City Commission
June 3, 2008

Gables Waterway

The Planning Department based upon the complete findings of fact contained within the Staff report recommends denial of the five (5) applications referred to as “Gables Waterway”
(pg 2)

1. Incompatible transition of uses (pgs 15-18)

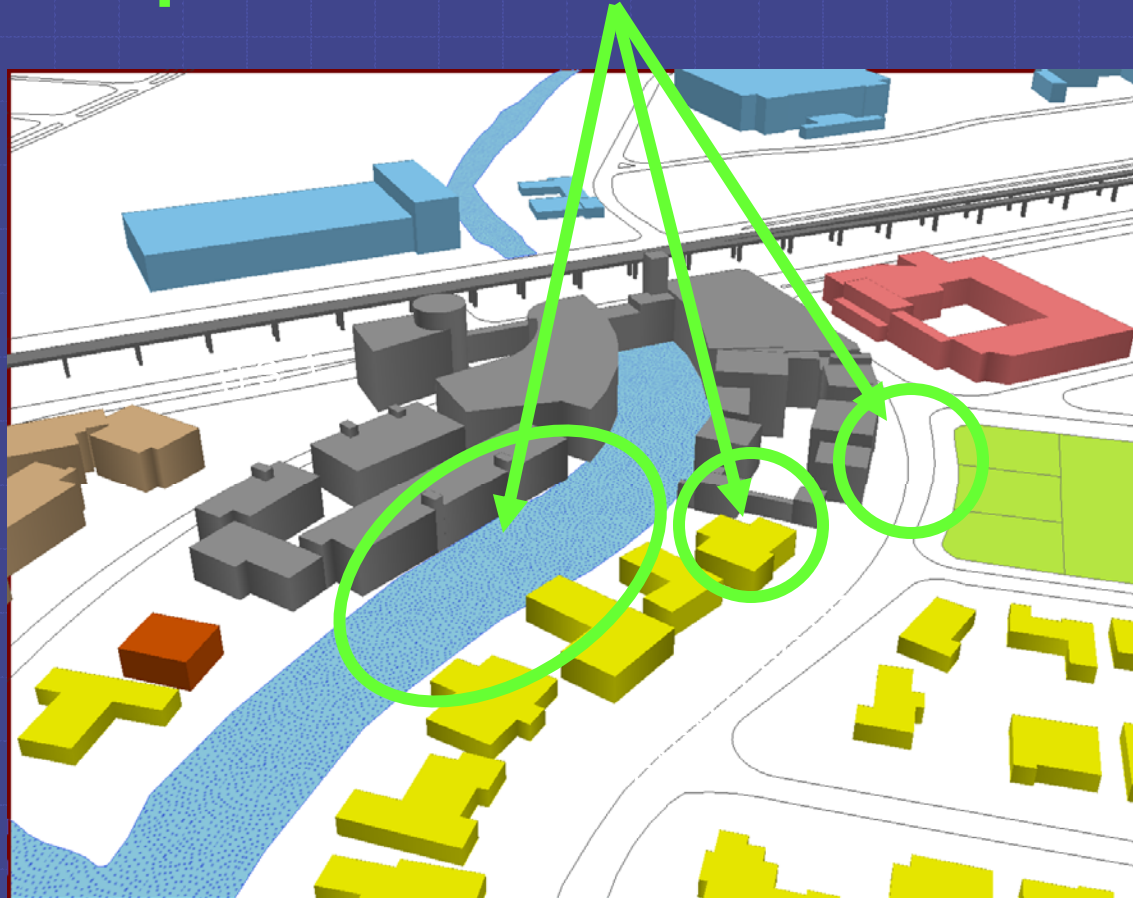
- Project does not provide adequate **transition of uses**
- Project does not allow for effective transition between uses along **Caballero Boulevard**, and is not consistent with professional planning practices of requiring a **transitional land use** between the existing single-family residential use and proposed multi-family residential use
- The existing land use pattern fulfills that objective and provides the transitional **duplex use** between the existing single-family residential use and multi-family residential use

2. Incompatible transition of massing (pgs 15-18)

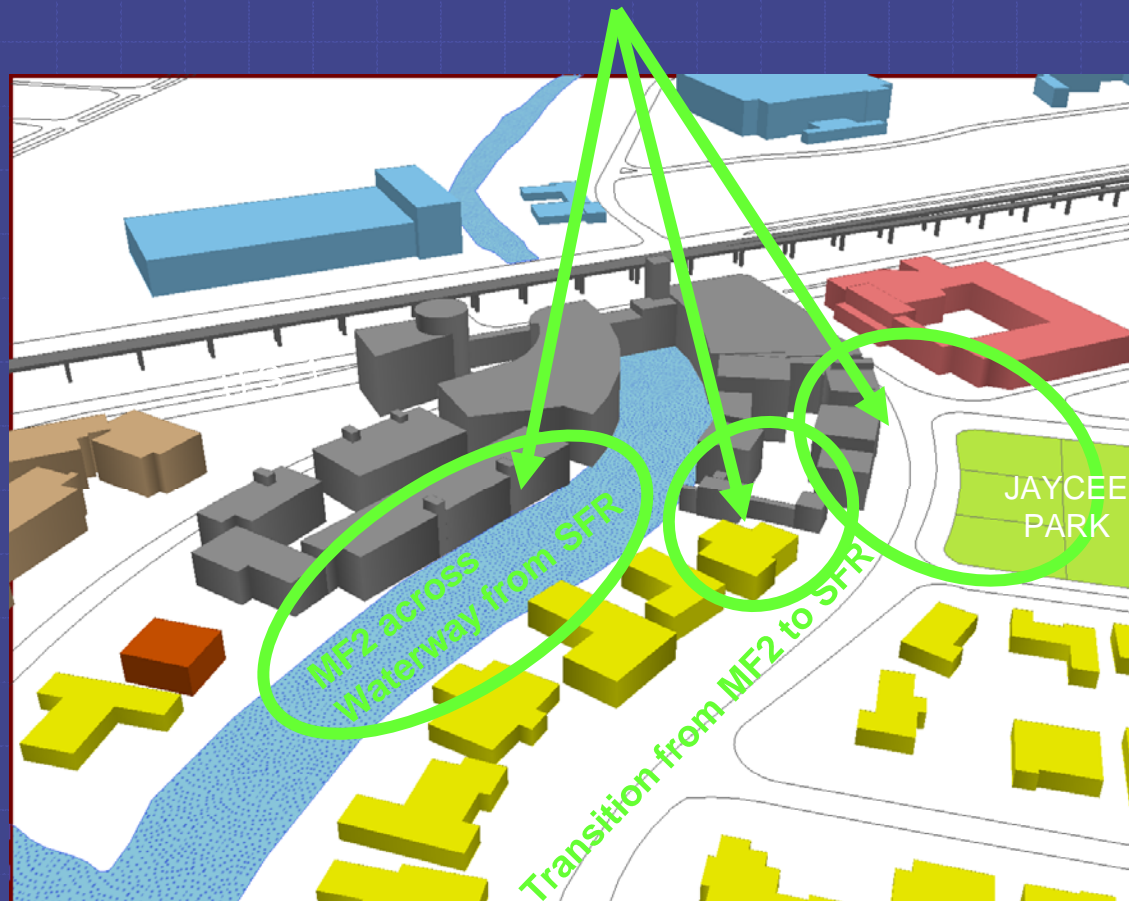
- Project does not provide adequate **transition of massing**
- Project does not provide adequate transition in **height and scale** from U.S.1 back to the existing single-family and duplex uses
- 5 story height of residential building across from **Jaycee Park**, and proposed reduction of both the required **front and rear setback** of the project's multi-family residential structures would impact adjoining properties and single-family residences located across the canal

Required setback relief

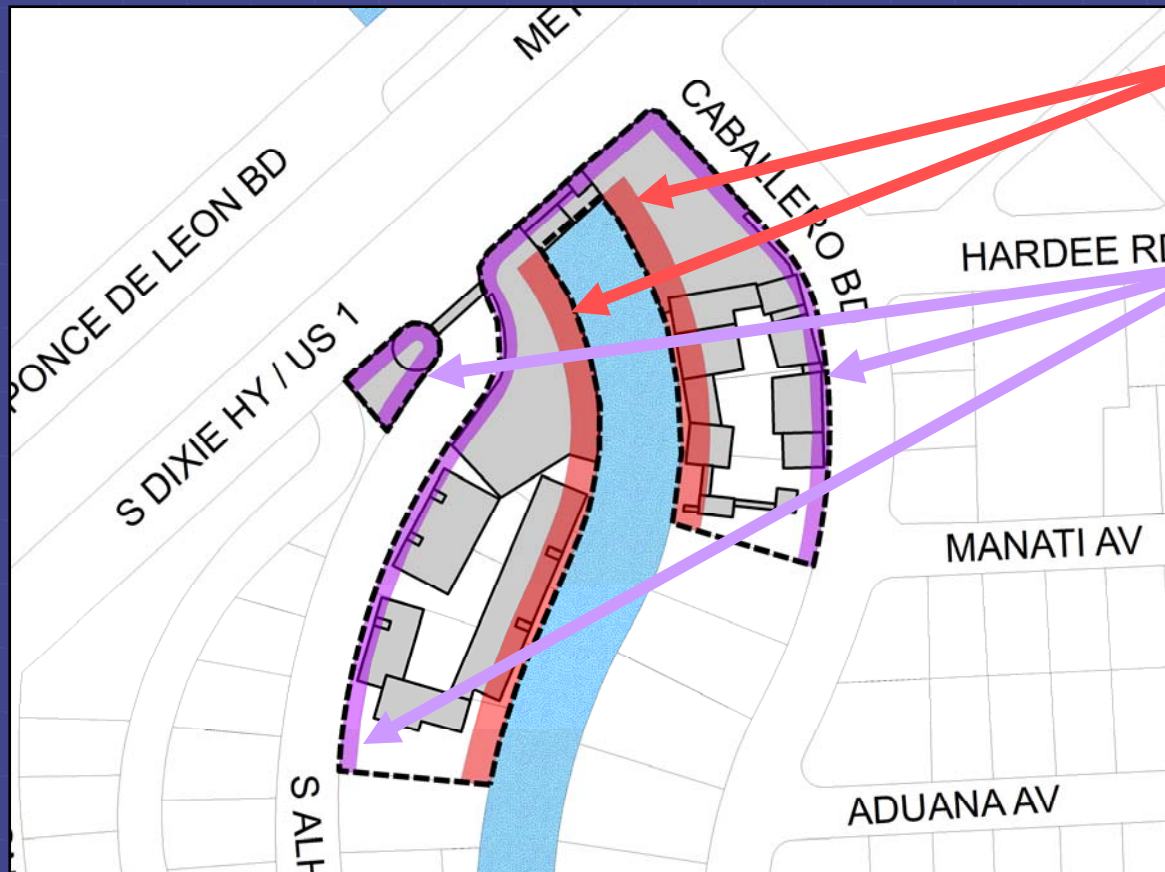
Rear setback
required 35' vs
proposed 0'-6'

Front setback
required 17'-25' vs
proposed 0'-10'

Potential off-site parking encroachment

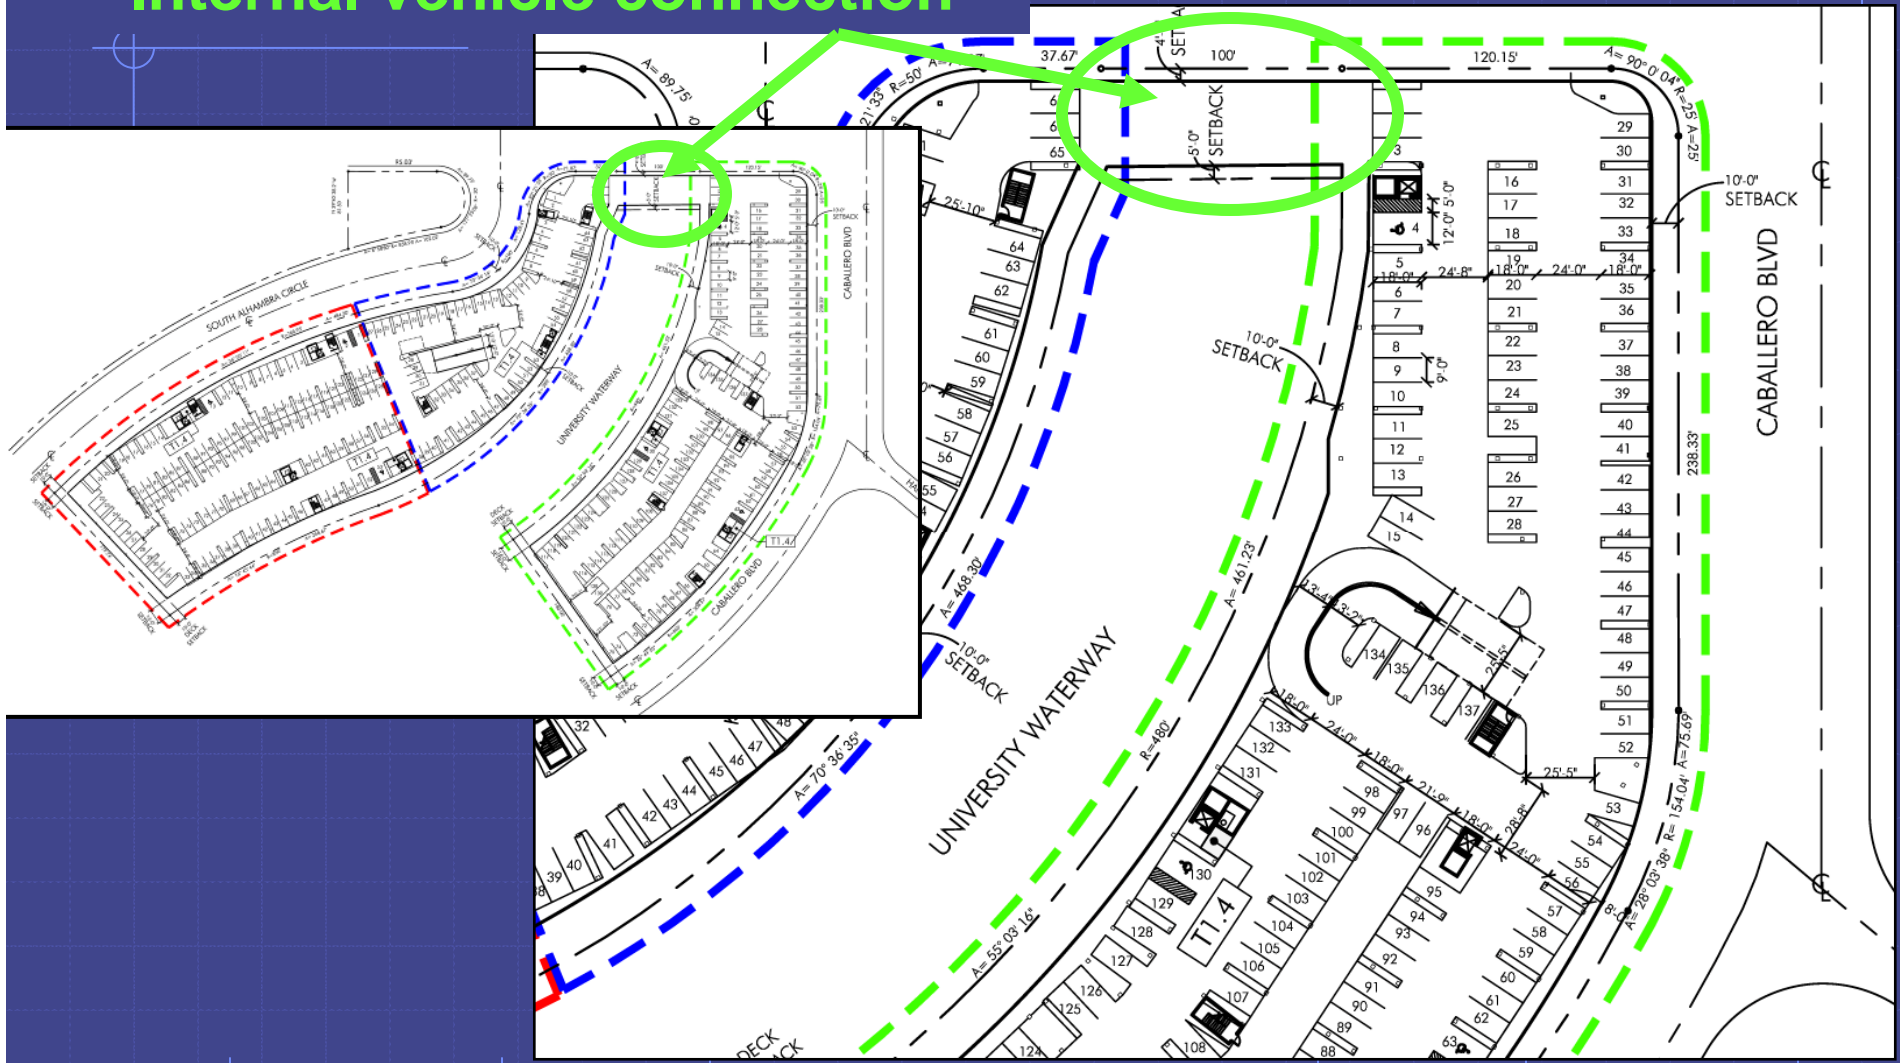
4. **Potential off-site parking encroachment (pgs 21-23)**
- Parking generated by the project could **encroach into the surrounding neighborhood** if left unmanaged
 - **No overflow parking management plan**, including short term meters, residential parking permits, directional signage and enforcement measures is provided to ensure that parking does not spill over into the surrounding residential neighborhood.
 - No plans provided for the proposed **vehicle connection** between the underground parking areas that would allow and encourage on-site vehicular circulation

Lack of marina facilities operation plan

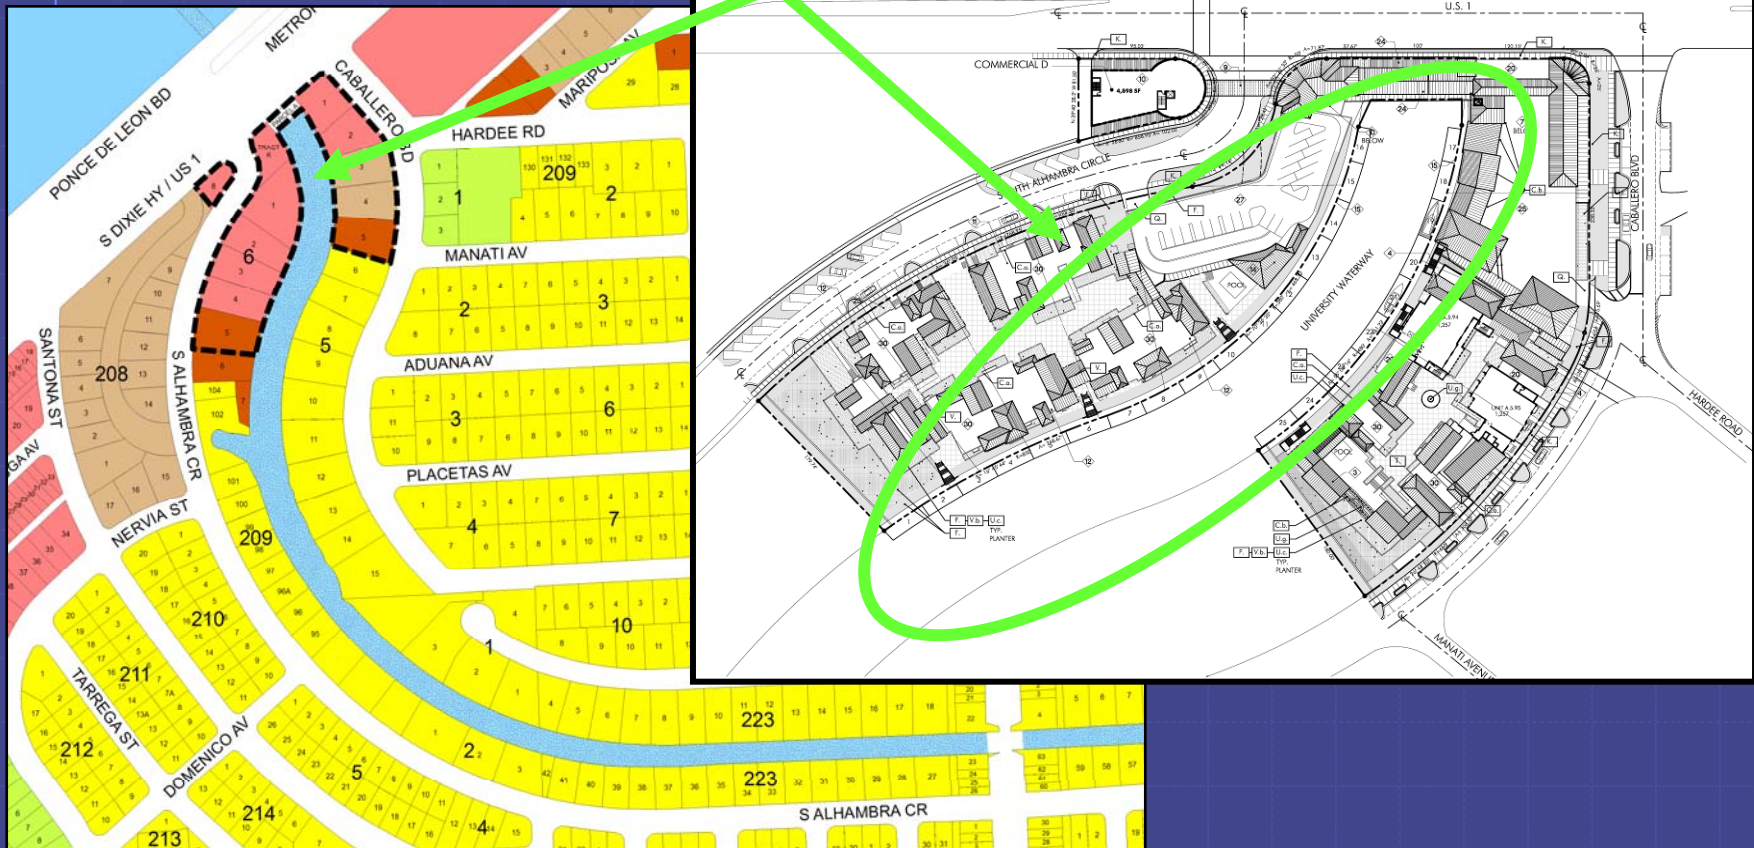
- Project will result in **increased use of existing marina** situated along **ecologically sensitive canal habitat**, which, if left unmanaged, could negatively impact the canal and surrounding single-family residential neighborhood
- **No operational plan provided** for the renovation and use of the existing 25 boat berths that are proposed to be assigned to owners of new residential units
- Marina is located at the end of a canal utilized primarily by the existing single-family residential neighborhood through which the canal courses, and serves as an environmentally sensitive manatee habitat
- Application **does not sufficiently address the servicing of vessels** at the marina to ensure there is minimal impact on the surrounding residential neighborhood and existing manatee habitat along the waterway
